Mount Emerald Wind Farm Traffic Impact Assessment

Technical Note 2 - Traffic Impact Assessment Engineering Response

Traffic Impact Questions 23 to 26 | Rev 1

Response to Ministerial Call-In Information Request - TRAFFIC

Appendix C. Vertical Geometry Drawings (From SKM 2012, Appendix C)

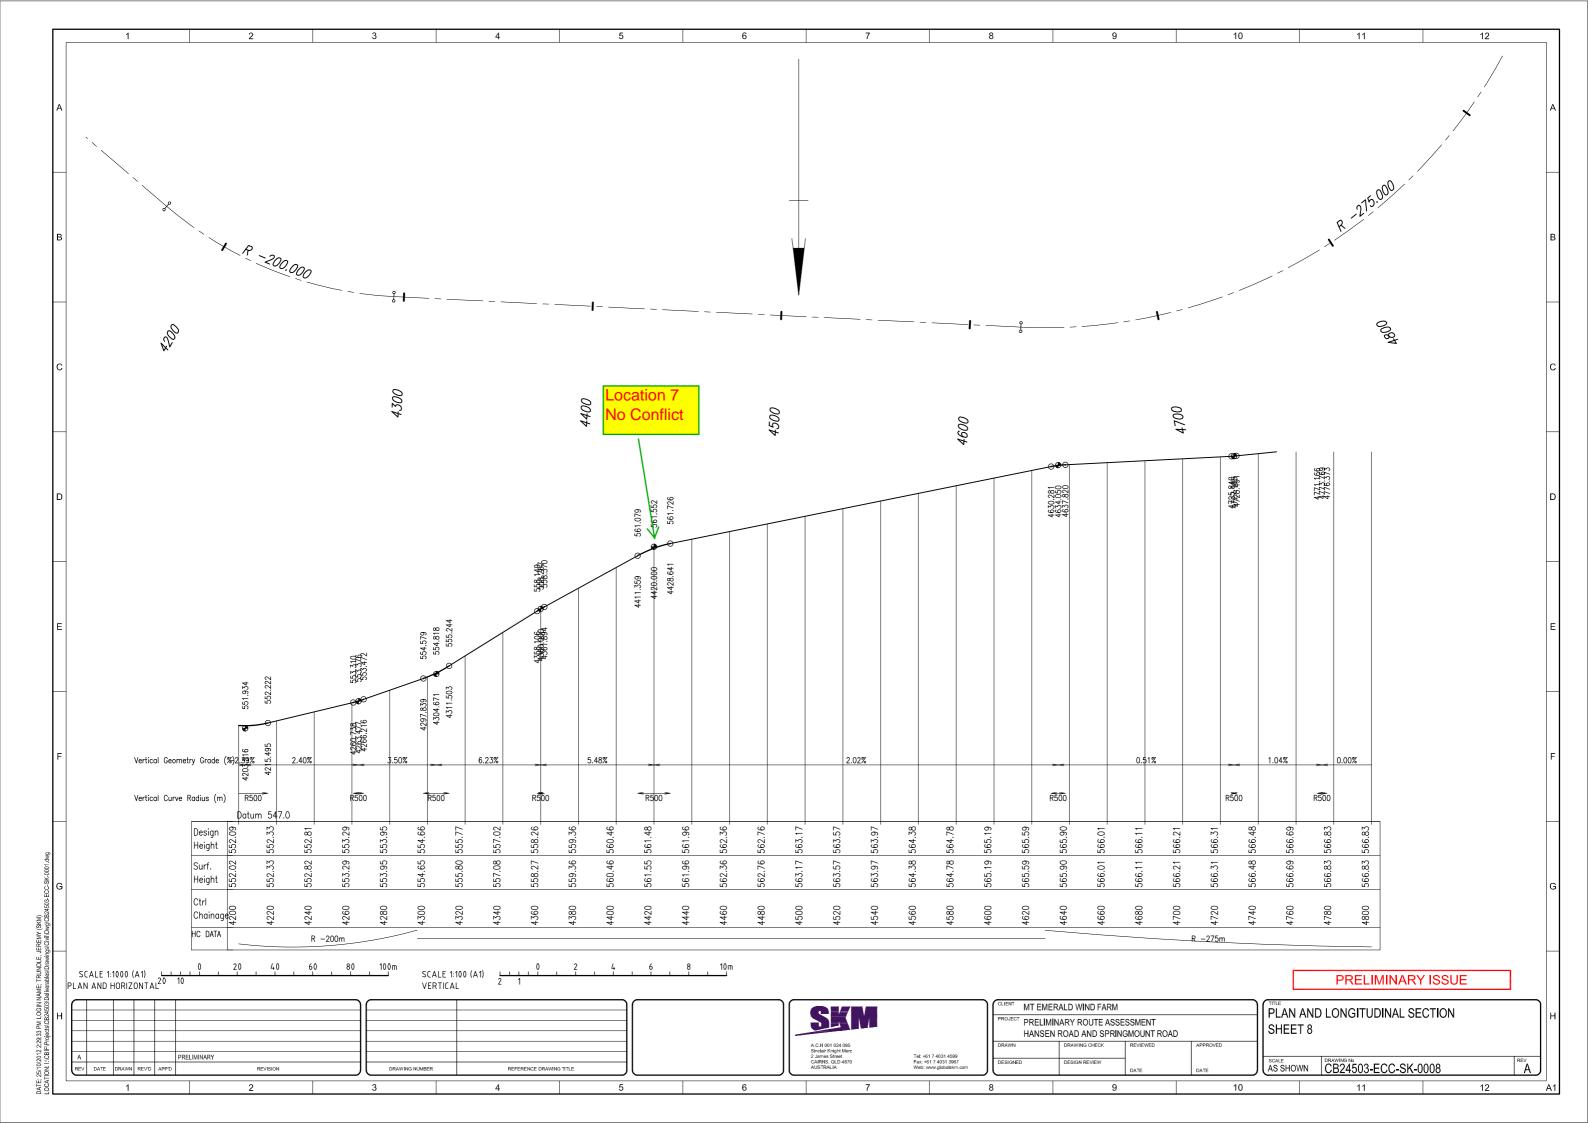
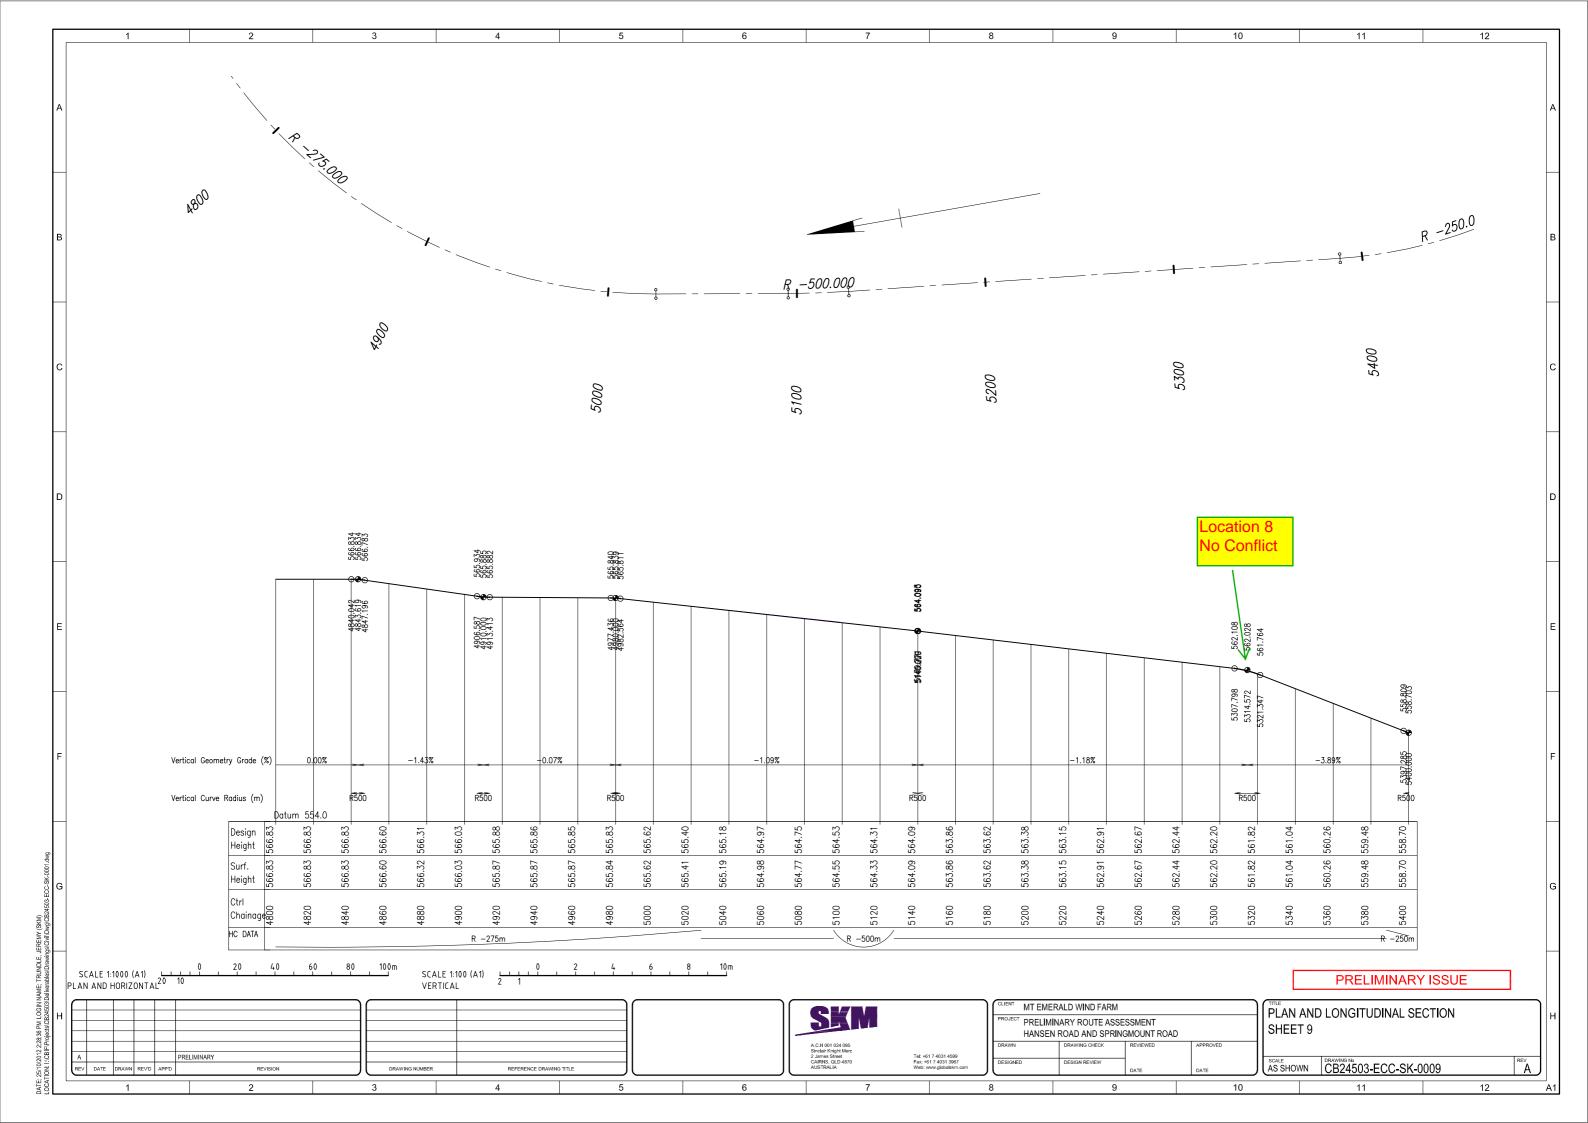
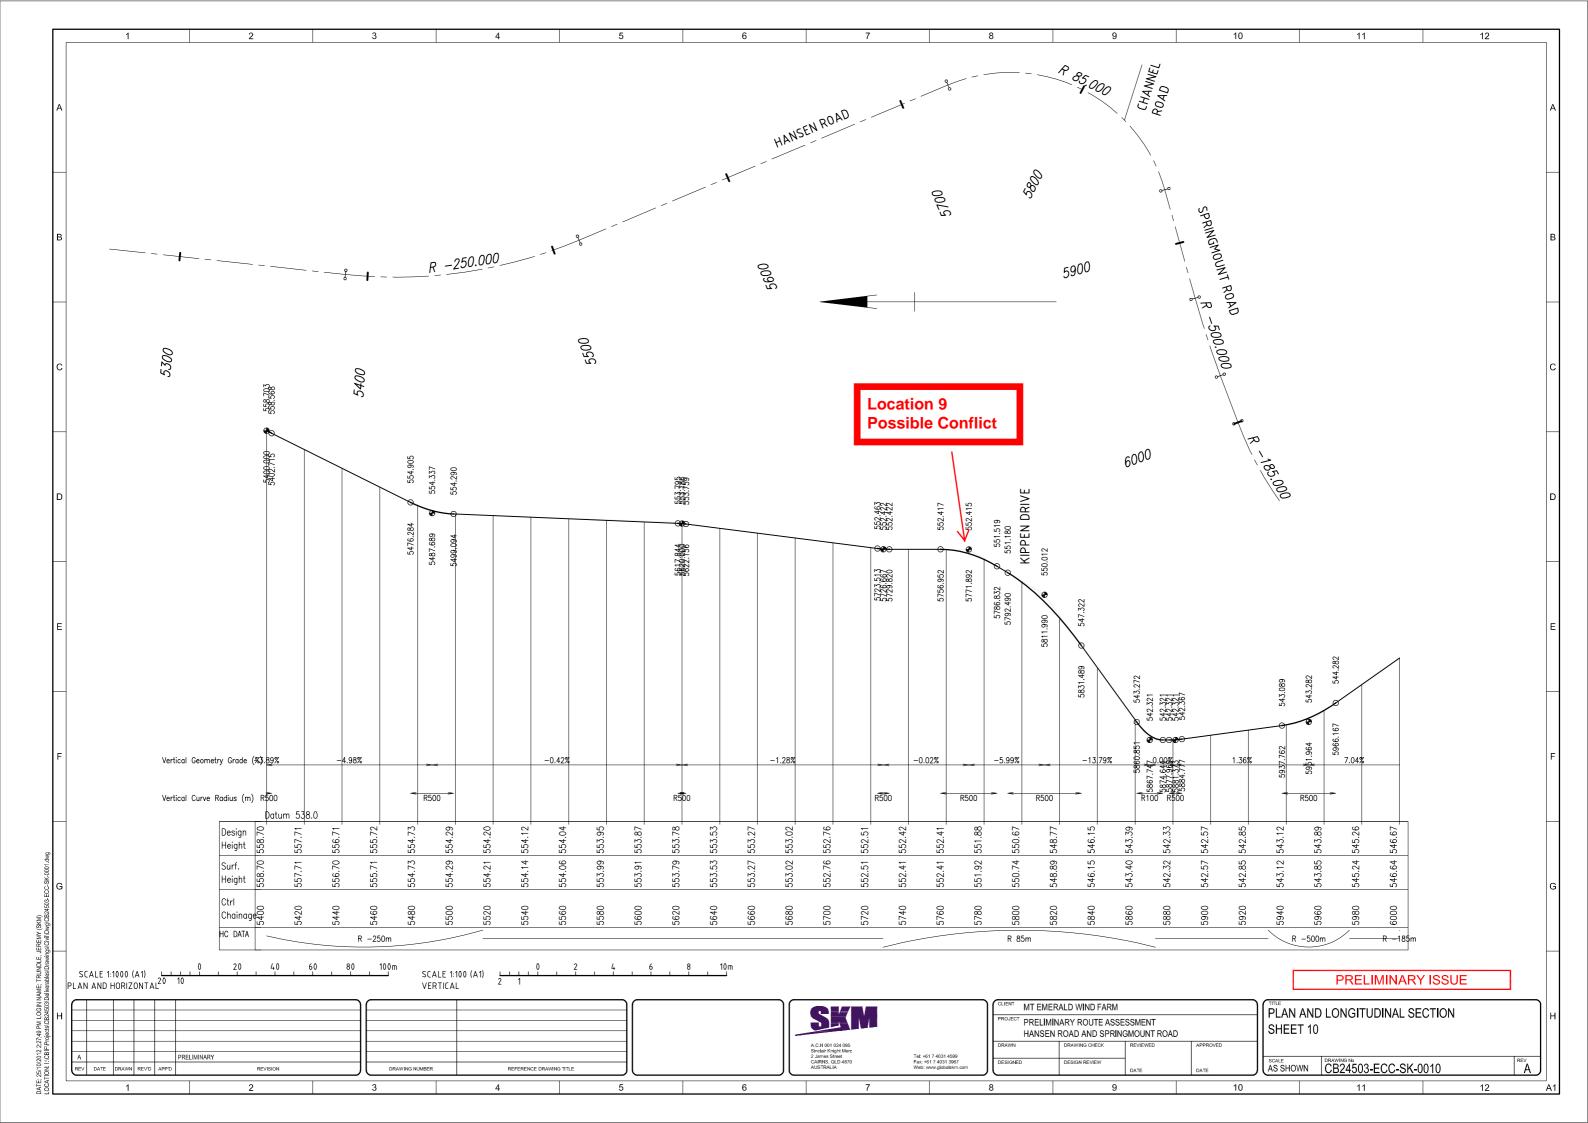
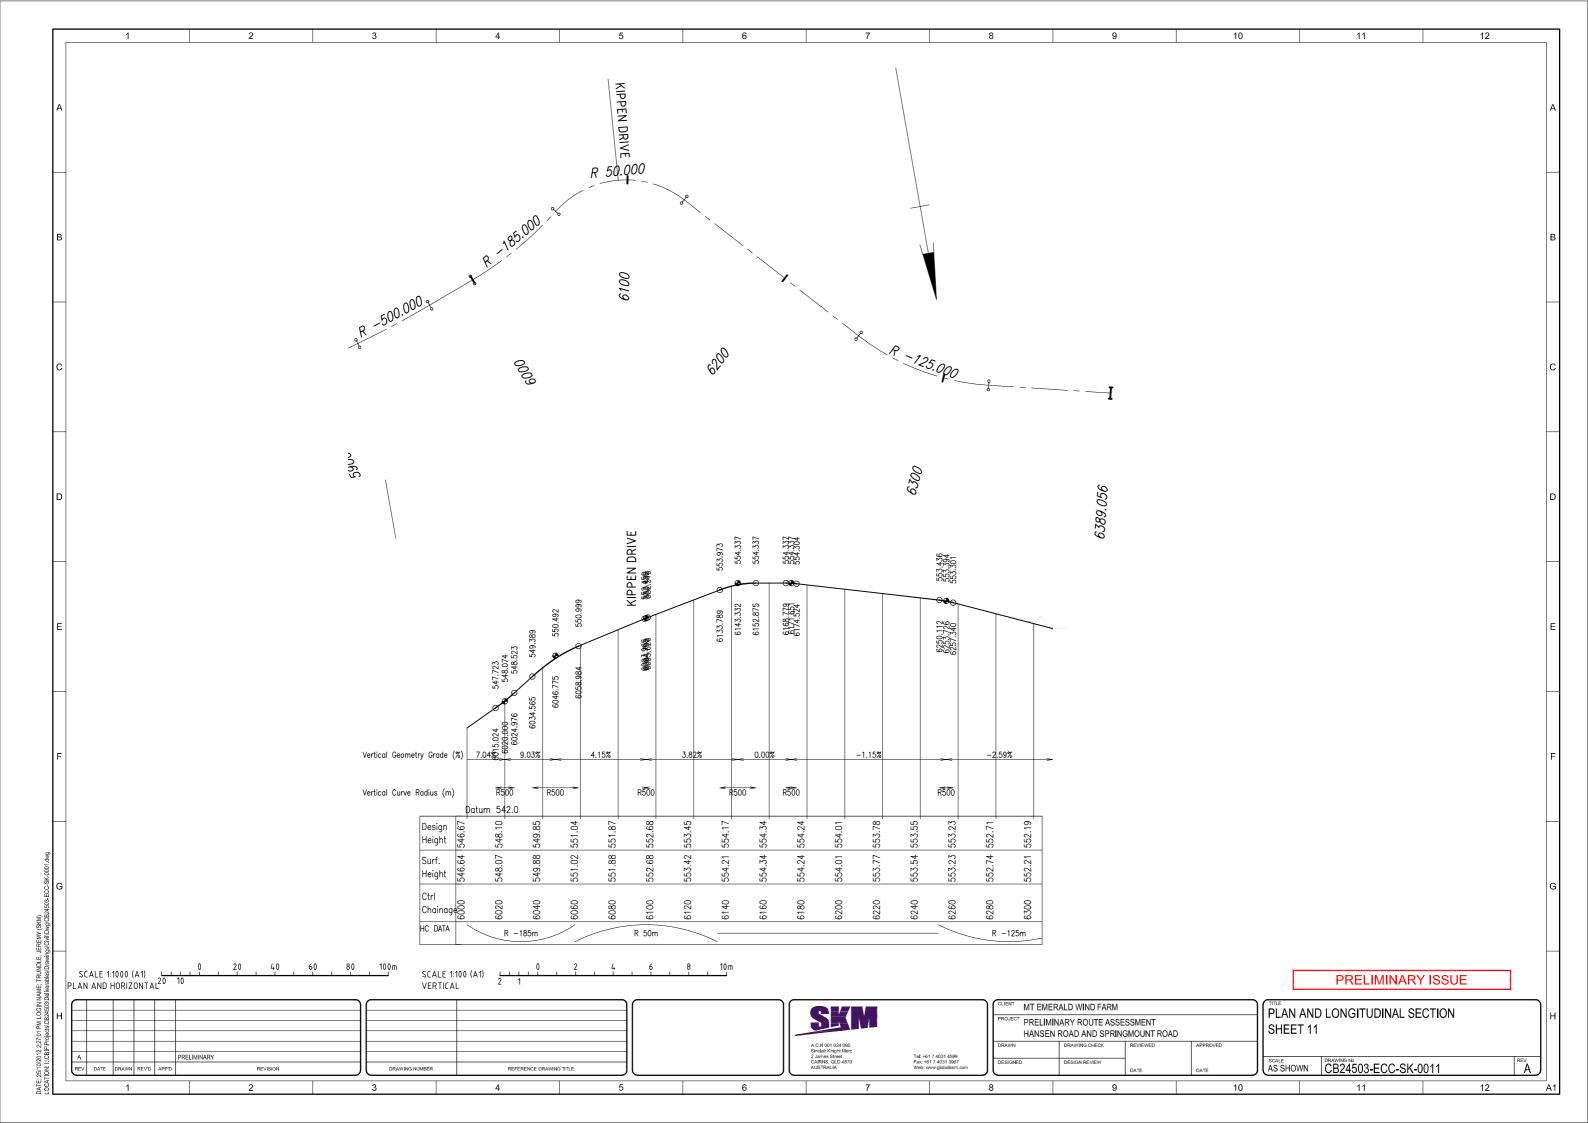
An assessment of the access to site (along Hansen Road and Springmount Road) for vertical geometry which utilises recent survey data.

TRC 51 Demonstrating the capability of the vertical profiles of Hansen and Springmount
 Roads accommodating any proposed drop deck or low loader transport of turbine components

To the best of our knowledge, recent survey or adequate topographical data does not exist at this time to allow a more detailed assessment of the access to site via Hansen Road and Springmount Road. Several sources were investigated, including the Queensland Government's Physical Road Network, and Geoscience Australia's Digital Topographic Data. However, at the time of this report, the Digital Elevation Model (DEM) has insufficient detail to perform such an investigation, and the Physical Road Network currently provides horizontal geometry only. In addition, survey from remote-sensing methods, such as Light Detection and Ranging (LiDAR), does not currently exist.

The Technical Note: Mount Emerald Wind Farm Traffic Impact Assessment Engineering Responses, undertaken by SKM 2012, provides a response to a query from the TRC, "Demonstrating the capability of the vertical profiles of Hansen and Springmount Roads accommodating any proposed drop deck or low loader transport of turbine components." This assessment of vertical geometry was based on a best fit to the GPS data recorded during a vehicle drive-through of the route as no detailed survey existed. The response to TRC 51 is included for information in Appendix B and the longitudinal sections, issued as Appendix C of the SKM 2012 technical report, are included in Appendix C of this report.

Review of Vertical pr	ofiles along Hansen and Springmount Road
Location	Chainage	Possible conflict with vertical profile	Comments
1	200	Checked - no conflict	Refer Drawings in Appendix B
2	1620	Checked - no conflict	Refer Drawings in Appendix B
3	1920	Checked - no conflict	Refer Drawings in Appendix B
4	2900	Checked - no conflict	Refer Drawings in Appendix B
5	3440	Checked - no conflict	Refer Drawings in Appendix B
6	4170	Checked - no conflict	Refer Drawings in Appendix B
7	4420	Checked - no conflict	Refer Drawings in Appendix B
8	5320	Checked - no conflict	Refer Drawings in Appendix B
9	5775	Checked - possible conflict	* Eastern approach to Granite Creek causeway. As per Acciona Windpower AW3000 specification for low loaders, there is possible conflict. However, acceptable per REPower Systems Specification for blade transportation. It should be noted that this assessment was done purely from GPS survey coordinates and the road may have flatter surface profiles in reality. Recommend detail survey or refer to as constructed drawings to confirm crest details from ch 5740 to 5820.

- Detail survey for the section of the road should be undertaken.
- After review of the survey and detailed reassessment of the conflict section, if the conflict remains, improvement to the vertical curve is recommended.
